**FILE NO.:** HR 16-09, HR 16-10, HR 16-11, HR 16-12, HR 16-13, and HR 16-14: Historic Review for the designs of seven (7) cottage style homes in the Canemah Historic District.

**REQUEST:** The applicant is requesting design approval for the construction of seven (7) new construction cottage style dwelling units, with preservation incentives to adjustment the front, side, and rear setbacks, in the Canemah Historic District.

**RECOMMENDATION:** Approval with Conditions

## Proposed House 1:

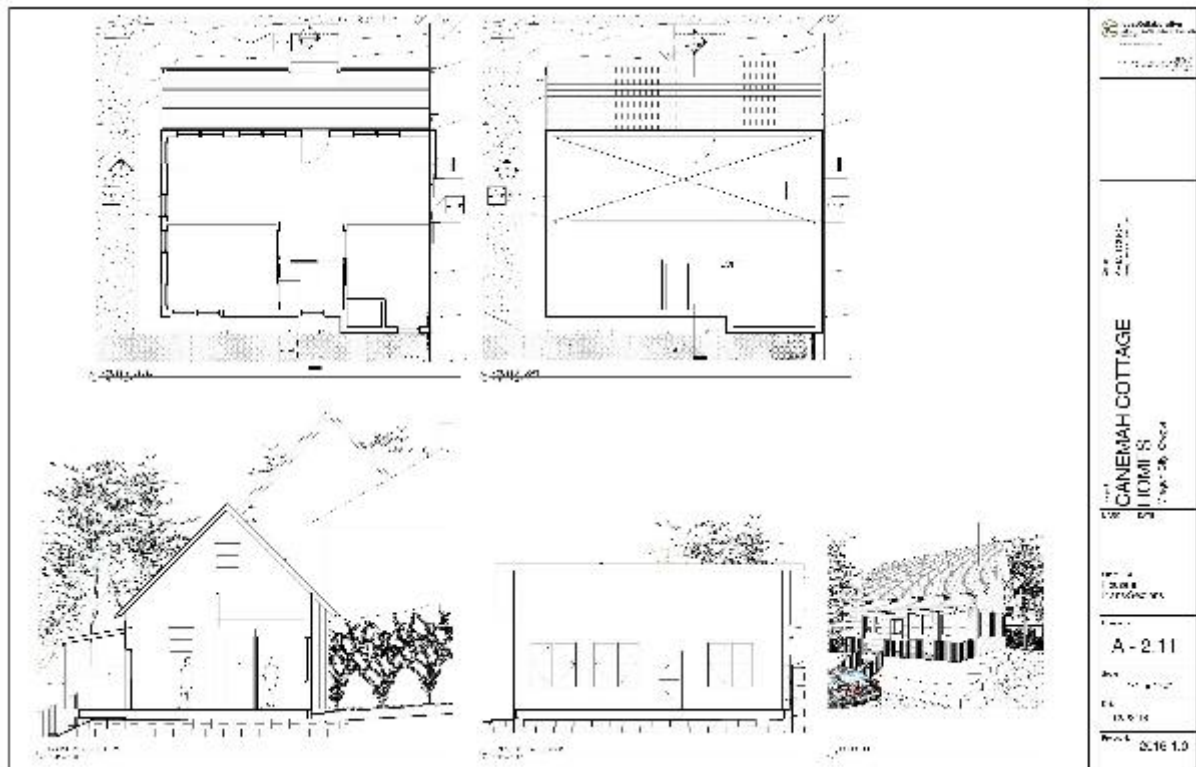
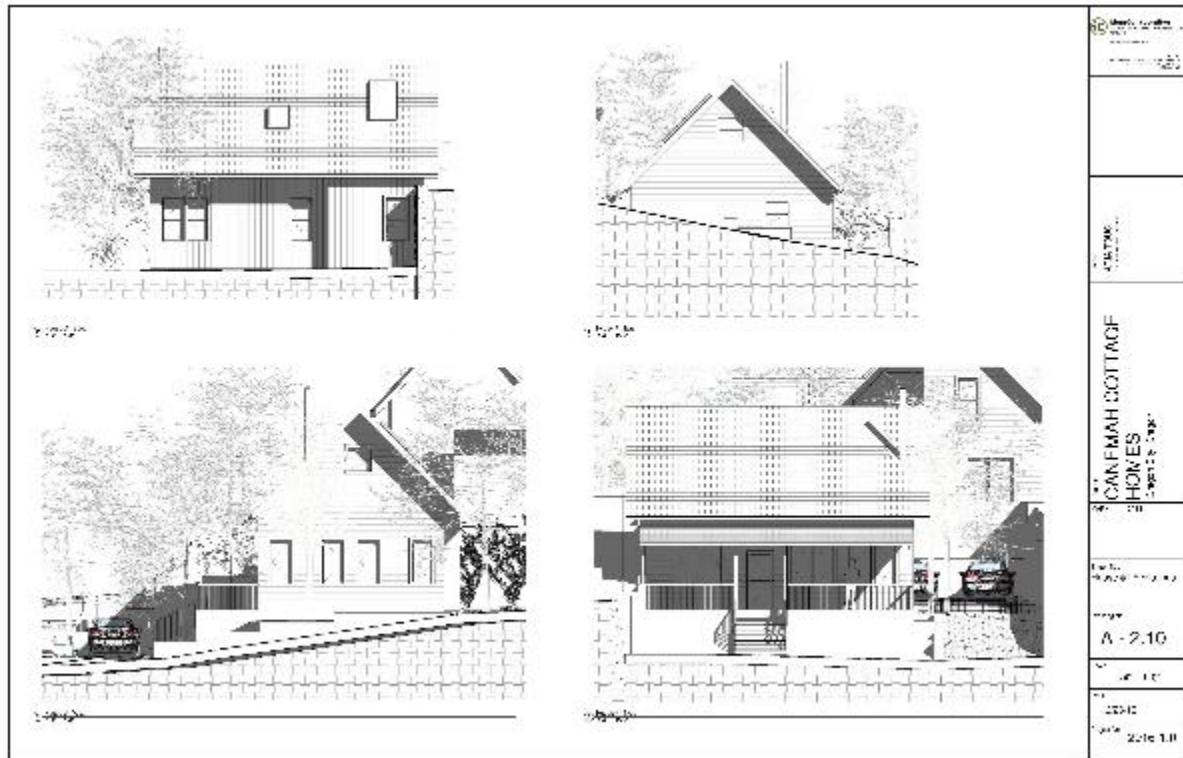
**Finding: Complies with Condition.** This house is designed to be a 600 square foot 1 ½ story home oriented towards 4<sup>th</sup> Ave. with an elevated front deck on the front of the house. The deck will have

In the design of home number one, the applicant has indicated that they are planning to remove a significant portion of the abutting topography, creating a cutout for the home and a twelve (12) foot wide driveway on the existing lot. This home will also be located directly upon the east property line.

The applicant will need to go through Geotechnical Review along with Site Plan and Design Review. A condition of approval has been written to ensure compatibility with the design standards of the Canemah Historic District

- a. Retaining and structural walls shall be minimized; to be faced or finished in stone, mortared basalt, or concrete, and not exceed 3 ½ feet, to complement the Canemah Neighborhood.
- b. Concrete foundations shall have a natural, parged or painted finish.
- c. Exposed foundations shall be site screened with vegetation if concrete or masonry exceeds 3½ feet, or if pilings or posts are 1½ feet above grade.
- d. Roofing shall use traditional materials such as wood shingles, composition, and metal shingles.
- e. Skylights shall be installed in inconspicuous roof slopes and skylights shall be mounted close to the roof plane, and not visible from the right-of-way.

## Proposed House 2:

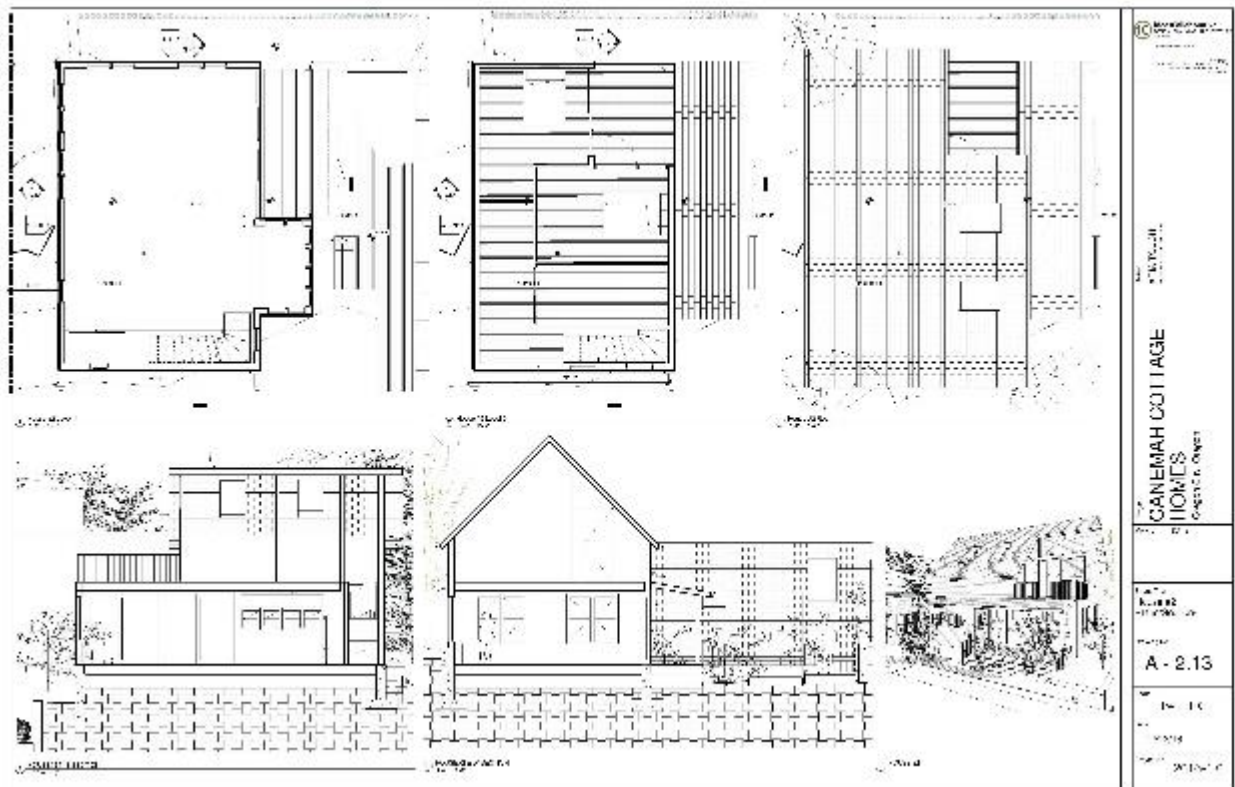
**Finding: Complies with Condition.** House two (2) is located approximately 40 feet south of house one (1) on the site plan, and appears to be designed as an 1100 square foot 1 ½ story modern Vernacular home completely sided in horizontal shiplap. The deck on east side of the house is with a flat, slightly elevated, with no front railing. The east side of the first story is has four large full light windows, creating a French door like entrance. To the south of the main entrance is a small bump out from the main building on which there are four small square double hung windows. To the south of the bump out is one large rectangular double hung window. The east facing deck is also covered by overhanging eave. On the second story of the east side there is a portion of the roof that has been removed to make space for a second story outdoor seating area. The entrance leading to this outdoor seating area is composed of two full light glass doors with two large square windows above the glass doors on the east side of the cutout and one full light glass door surrounded by window on south side of the cutout. The outdoor seating area is bordered on the east and west sides by a railing with thin spindles and a top rail. On north side of the first story there are four large rectangular double hung windows and one large rectangular double hung window on the second story.

The first story on the south side of the house contains one small square double hung window with a concrete planter box along the foundation of the building. The side of the east-facing bump out is visible on the south side of the house; there are two small square double hung windows visible on the side of said bump out. On the second story of the south side of the home, a series of stepped windows are used. A large double hung rectangular window is illustrated to be near the top of the structure, stepping down to two small double hung square windows.

- Identify the types of doors used on the entrance of the home and if they are contextually appropriate for the proposed development and in the Canemah Neighborhood.
- Identify if the roof cutout is an appropriate architectural feature for the Canemah Historic district.
- Identify what types of windows will be used on the doors and wall adjacent the second story outdoor space.
- Identify if there if the north elevation on home number 2 is correct.

- a. Residential doors shall complement the design and detailing of the historic style with similar appearance to wood. Doors shall be designed in a stile and rail type; panel design; with upper portion glass. The primary door may be a solid panel door. Sliding doors are not permitted on any part of the home.

- b. Gable roof slopes shall have equal pitch. Gable primary roofs shall have a pitch of 8:12 or greater (6:12 for Bungalow). Porch or bay roofs may have lower slope, may have hip if style allows. Roofs shall have a minimum 1 foot overhang with a maximum of 3 feet.

- c. Windows shall match the member sizing, thickness and shadowline of painted wood windows. Windows shall also consist of the following designs: double, single hung, or casement. Wood clad shall be matching in color and finish. Non-wood fiberglass and aluminum windows are acceptable if in appropriate style, and matching wood in profile, shadowline, and if similar in color and finish. If a non-wood style is proposed, a sample is required to be approved by the Historic Review Board.

- d. The applicant shall resubmit the elevation drawings to the Planning Division, the north elevation on House 2 appears to contain addition structure that is not present on other drawings.

**Proposed House 3:**

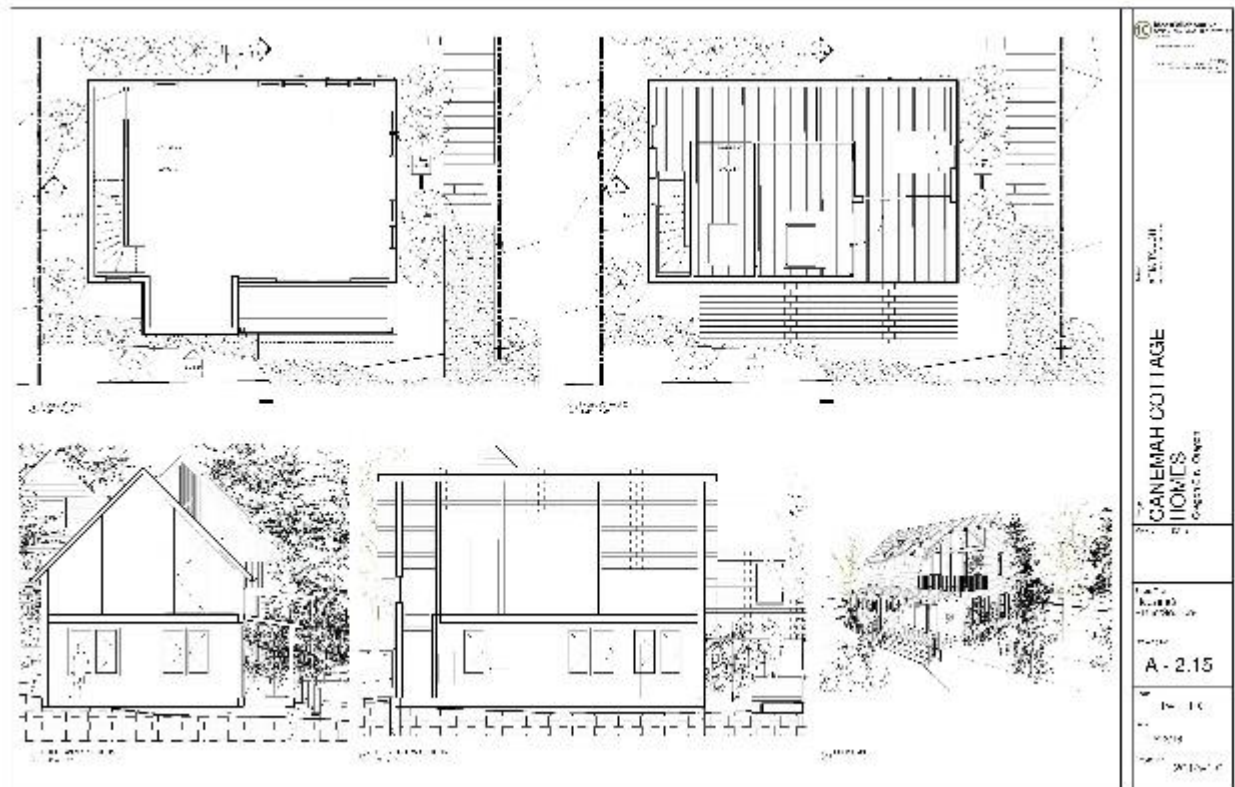
**Finding: Complies with Condition.** House number three is located approximately eight feet south of house number 2, and is exactly the same as house two but oriented north/south instead of east/west.

- a. Primary residential doors shall complement the design and detailing of the historic style with similar appearance to wood. Doors shall be designed in a stile and rail type; panel design; with upper portion glass. The primary door may be a solid panel door. Sliding doors are not permitted.

- b. Gable roof slopes shall have equal pitch. Gable primary roofs shall have a pitch of 8:12 or greater (6:12 for Bungalow). Porch or bay roofs may have lower slope, may have hip if style allows. Roofs shall have a minimum 1 foot overhang with a maximum of 3 feet.

- c. Windows shall match the member sizing, thickness and shadowline of painted wood windows. Windows shall also consist of the following designs: double, single hung, or casement. Wood clad shall be matching in color and finish. Non-wood fiberglass and aluminum windows are acceptable if in appropriate style, and matching wood in profile, shadowline, and if similar in color and finish. If a non-wood style is proposed, a sample is required to be approved by the Historic Review Board.

## Proposed House 4:

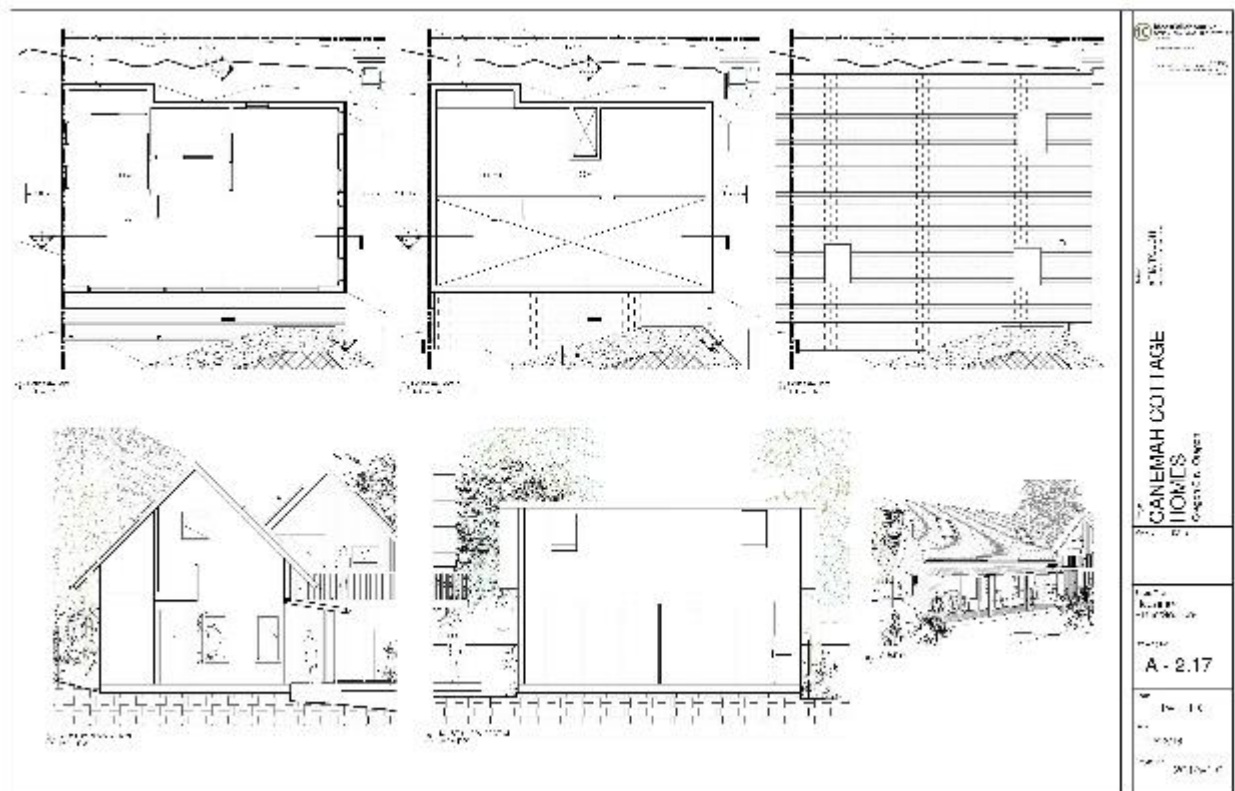
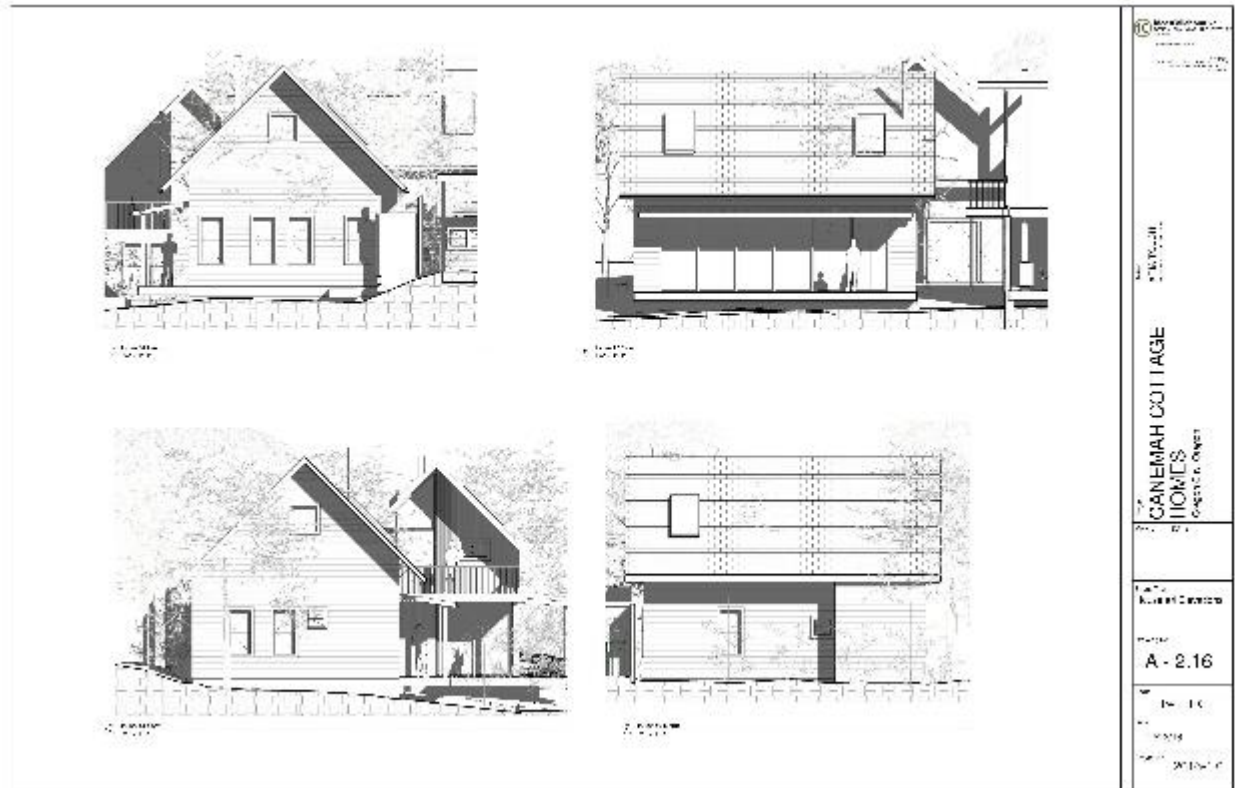
**Finding: Complies with Condition.** House seven is a 600 square foot 1 ½ story modern Vernacular, completely sided in horizontal shiplap, located approximately 24 feet to the east of house number three. The south side of the home consists of a flat deck with an eave covering the deck. There is a bank of six full light windows, creating a large open approach onto the deck.

- a. The main entrance of the house shall not be oriented towards the adjacent parking area.
- b. Residential doors shall complement the design and detailing of the historic style with similar appearance to wood. Doors shall be designed in a stile and rail type; panel design; with upper portion glass. The primary door may be a solid panel door. Sliding doors are not permitted on any portion of the house.

- c. Windows shall match the member sizing, thickness and shadowline of painted wood windows. Windows shall also consist of the following designs: double, single hung, or casement. Wood clad shall be matching in color and finish. Non-wood fiberglass and aluminum windows are acceptable if in appropriate style, and matching wood in profile, shadowline, and if similar in color and finish. If a non-wood style is proposed, a sample is required to be approved by the Historic Review Board.

- d. Gable roof slopes shall have equal pitch. Gable primary roofs shall have a pitch of 8:12 or greater (6:12 for Bungalow). Porch or bay roofs may have lower slope, may have hip if style allows. Roofs shall have a minimum 1 foot overhang with a maximum of 3 feet.

## Proposed House 5:

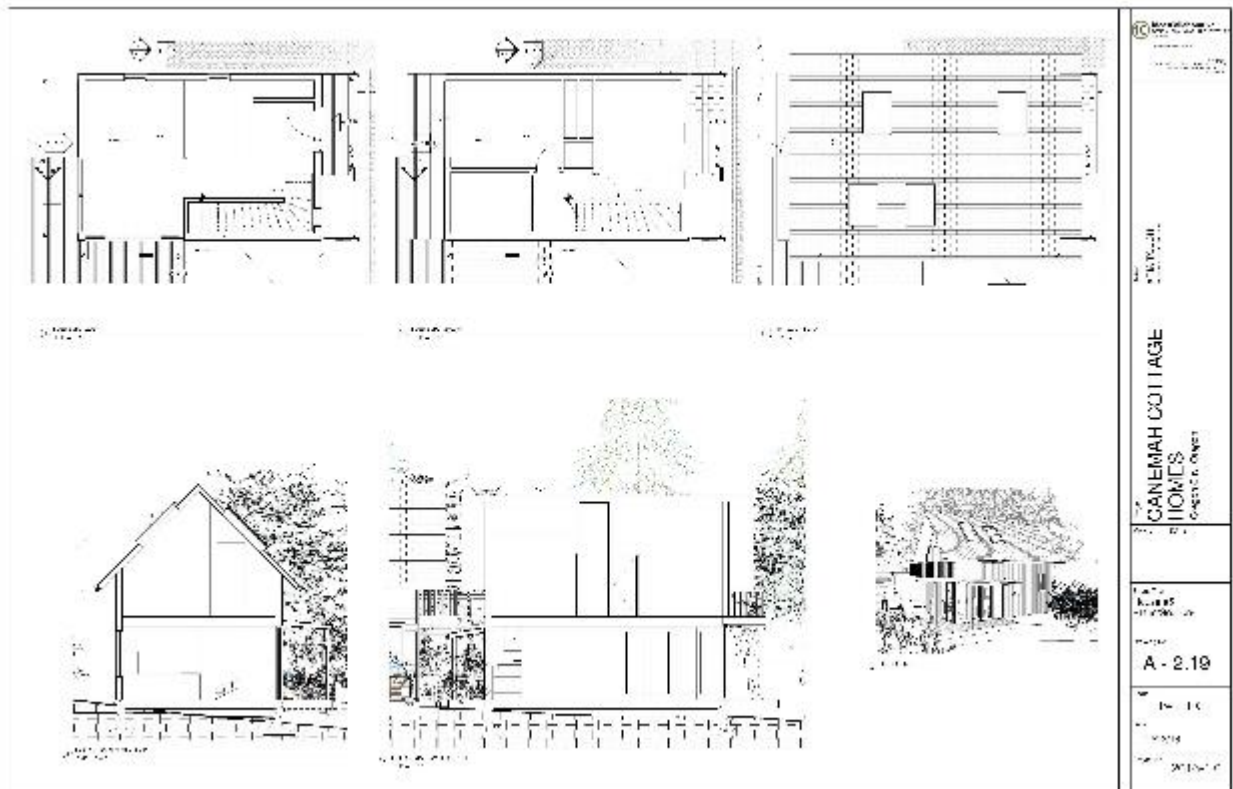
**Finding: Complies with Condition.** House four is an 800 square foot 1 ½ story modern Vernacular, completely sided in horizontal shiplap on the north, vertical shiplap on the south and west side, and vertical and horizontal shiplap on the east side. This house is located approximately 10 feet to the east of house number four.

- a. Windows shall match the member sizing, thickness and shadowline of painted wood windows. Windows shall also consist of the following designs: double, single hung, or casement. Wood clad shall be matching in color and finish. Non-wood fiberglass and aluminum windows are acceptable if in appropriate style, and matching wood in profile, shadowline, and if similar in color and finish. If a non-wood style is proposed, a sample is required to be approved by the Historic Review Board.
- b. Residential doors shall complement the design and detailing of the historic style with similar appearance to wood. Doors shall be designed in a stile and rail type; panel design; with upper

portion glass. The primary door may be a solid panel door. Sliding doors are not permitted on any portion of the house.

- c. Concrete foundations shall have a natural, parged or painted finish.
- d. Exposed foundations shall be site screened with vegetation if concrete or masonry exceeds 3½ feet, or if pilings or posts are 1½ feet above grade.
- e. Roofing shall use traditional materials such as wood shingles, composition, and metal shingles.
- f. Skylights shall be installed in inconspicuous roof slopes and skylights shall be mounted close to the roof plane, and not visible from the right-of-way.

## House 6:

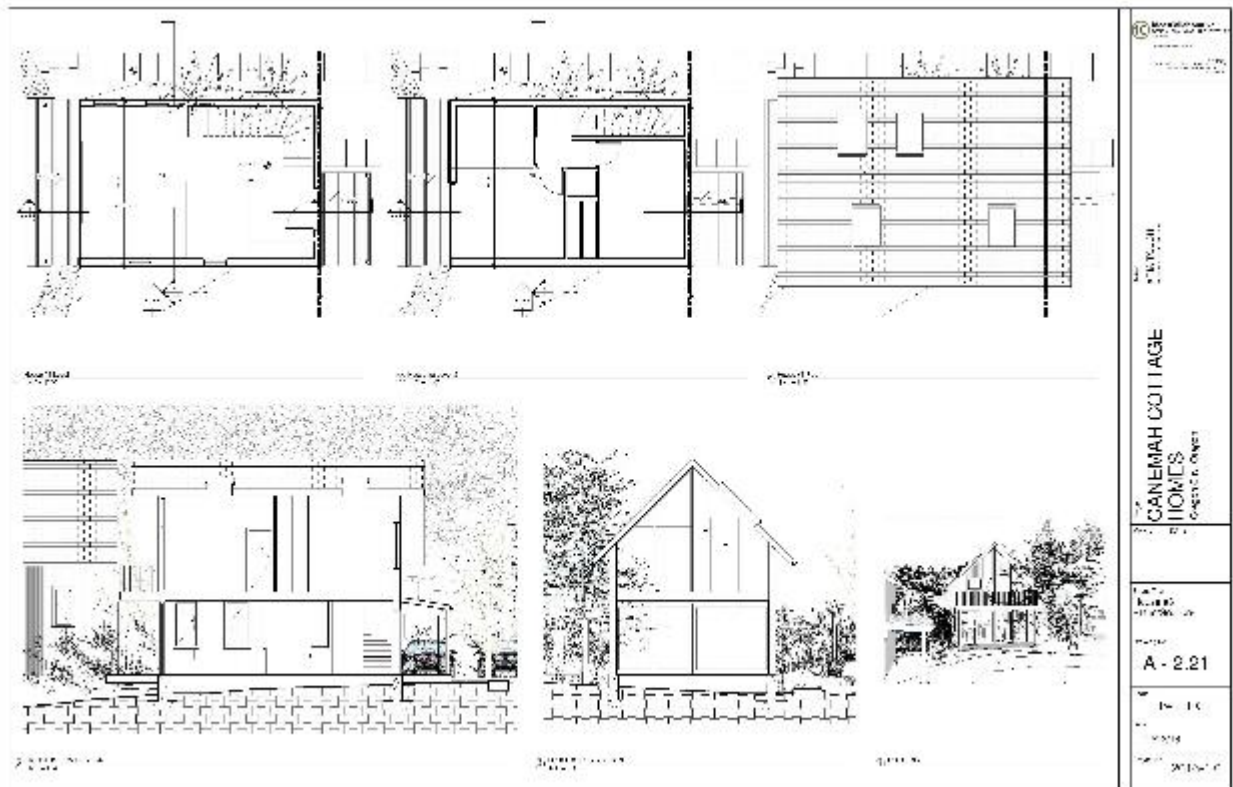
**Finding: Complies with Condition.** House four is an 800 square foot 1 ½ story modern Vernacular, completely sided in vertical shiplap on the west side, horizontal shiplap on the north and south, and vertical and horizontal shiplap on the east side. This house is located approximately 12 feet to the southeast of house number five.

- a. The main entrance of the house shall not be oriented towards the adjacent parking lot.
- b. Windows shall match the member sizing, thickness and shadowline of painted wood windows. Windows shall also consist of the following designs: double, single hung, or casement. Wood clad shall be matching in color and finish. Non-wood fiberglass and aluminum windows are acceptable if in appropriate style, and matching wood in profile, shadowline, and if similar in color and finish. If a non-wood style is proposed, a sample is required to be approved by the Historic Review Board.

- c. Residential doors shall complement the design and detailing of the historic style with similar appearance to wood. Doors shall be designed in a stile and rail type; panel design; with upper portion glass. The primary door may be a solid panel door. Sliding doors are not permitted on any portion of the house.

- d. Gable roof slopes shall have equal pitch. Gable primary roofs shall have a pitch of 8:12 or greater (6:12 for Bungalow). Porch or bay roofs may have lower slope, may have hip if style allows. Roofs shall have a minimum 1 foot overhang with a maximum of 3 feet.
